FLYING HORSE NORTH FILING NO. 9 CONSTRUCTION DRAWINGS

CONSTRUCTION DRAWINGS
COVER

LEGEND & NOTES

TYPICAL MODIFIED URBAN RESIDENTIAL LOCAL
CROSS SECTION

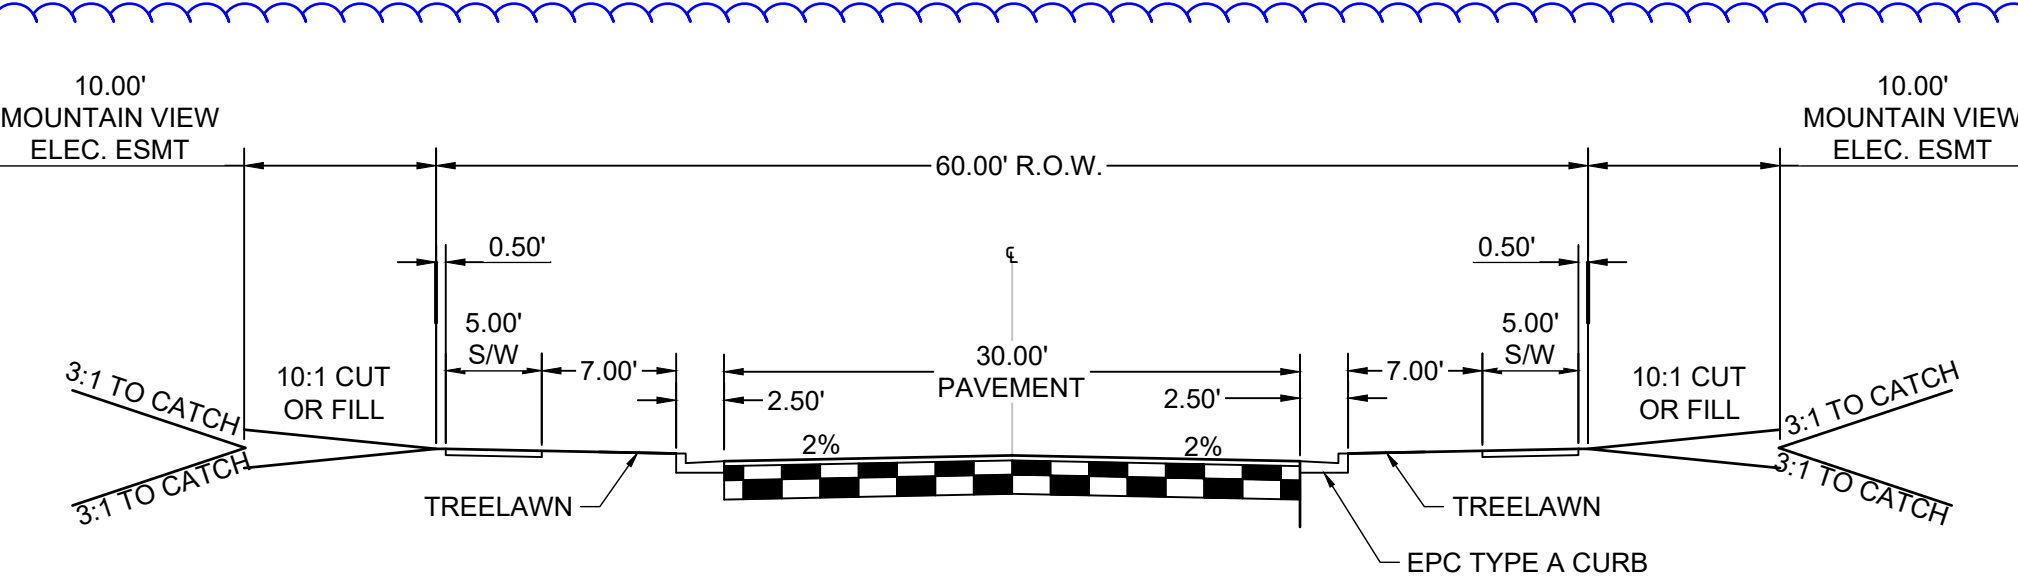
Where is this road section being proposed? It appears that Sorraia Way / Ace Way follows the typical urban local cross section above.

SIGNAGE & STRIPING PLAN

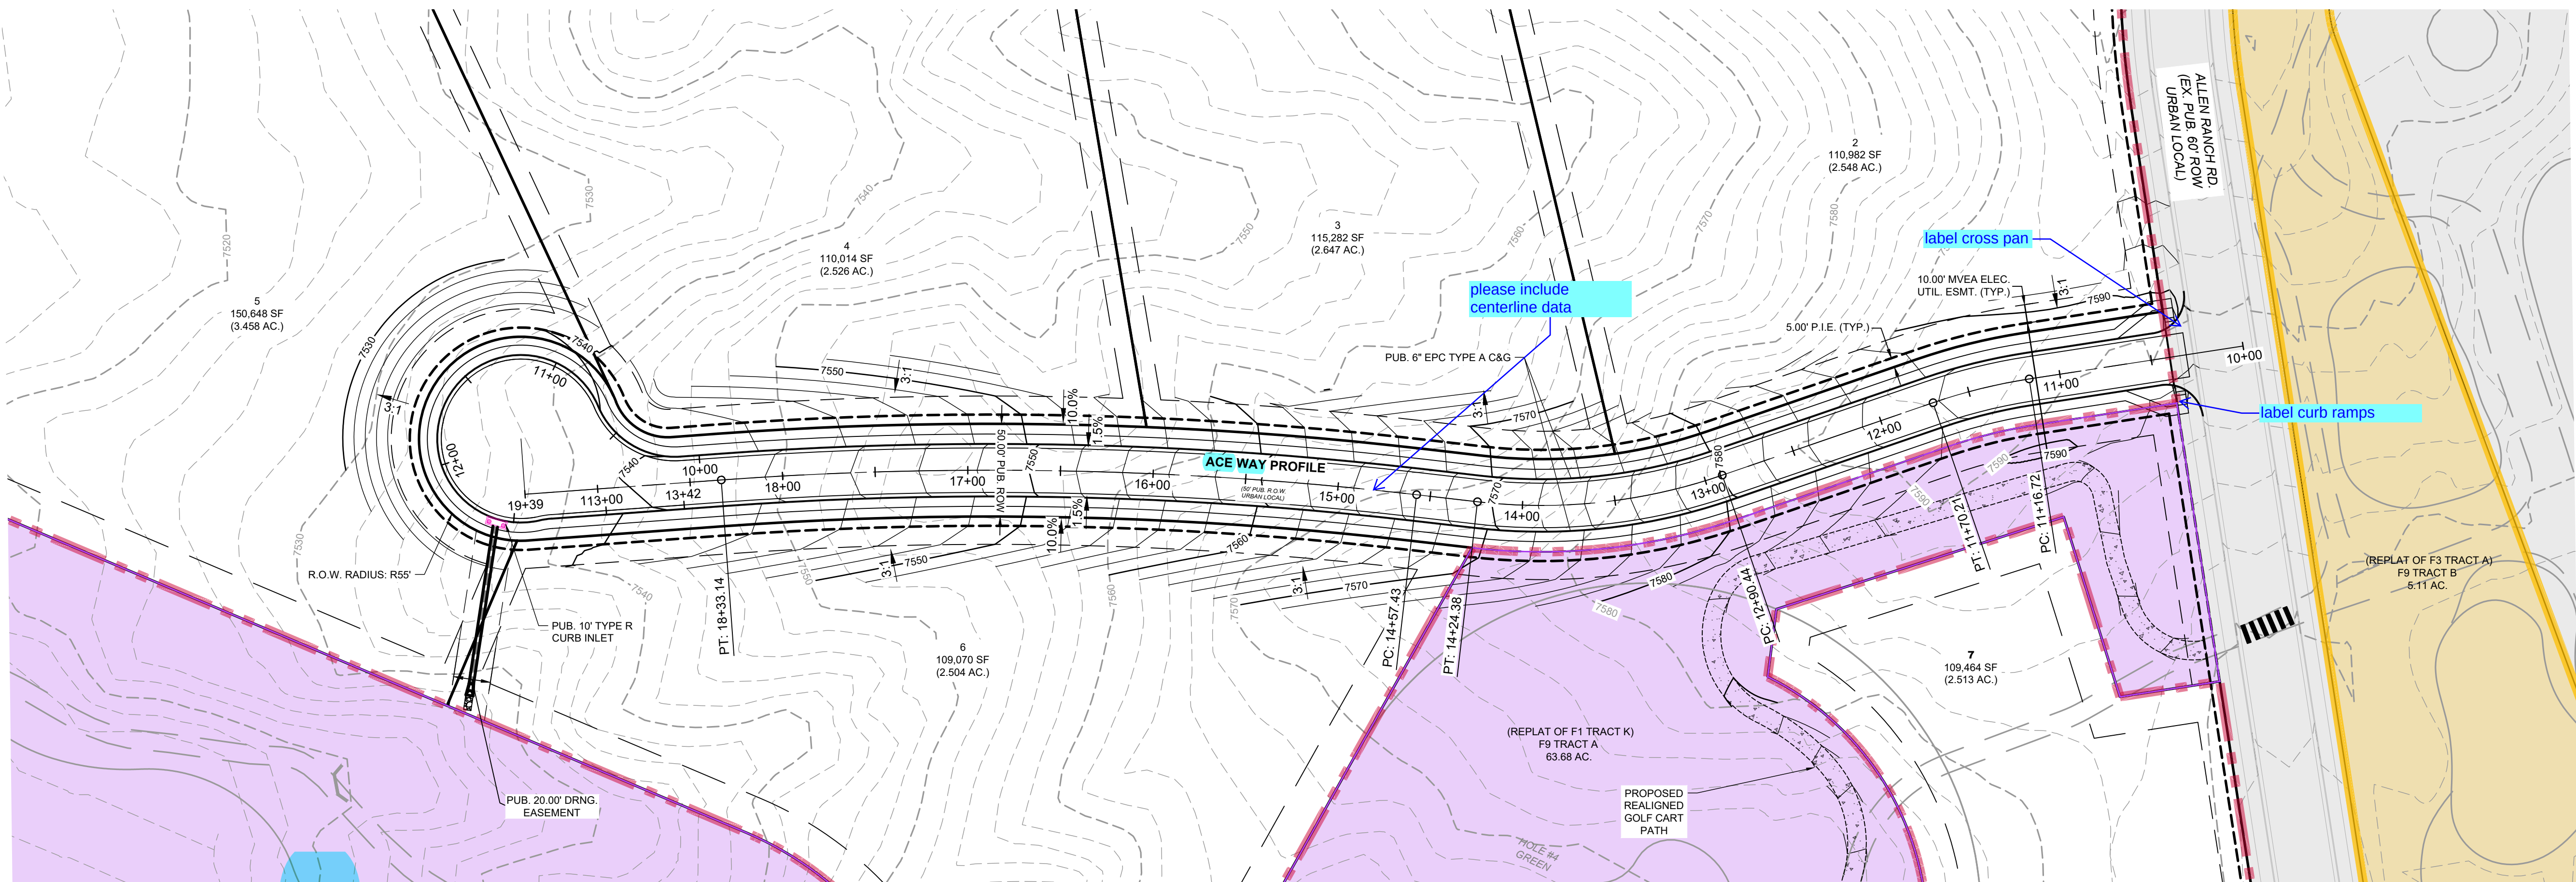
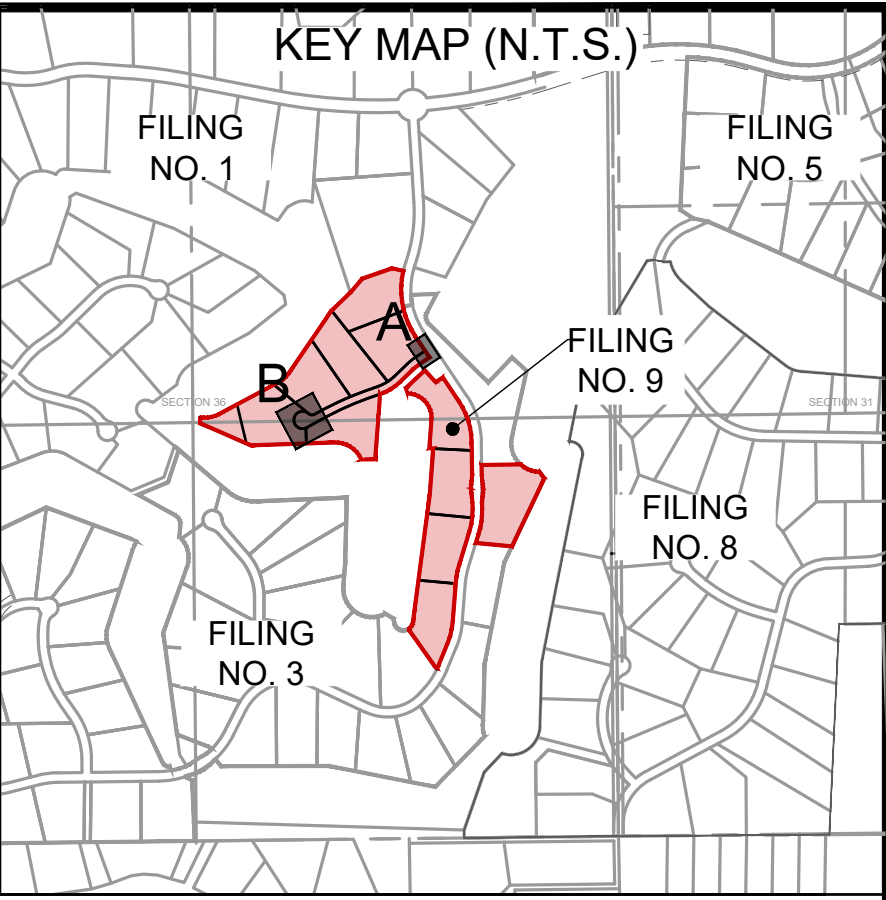
min 24x24

min 12x36

Min size is 18x24
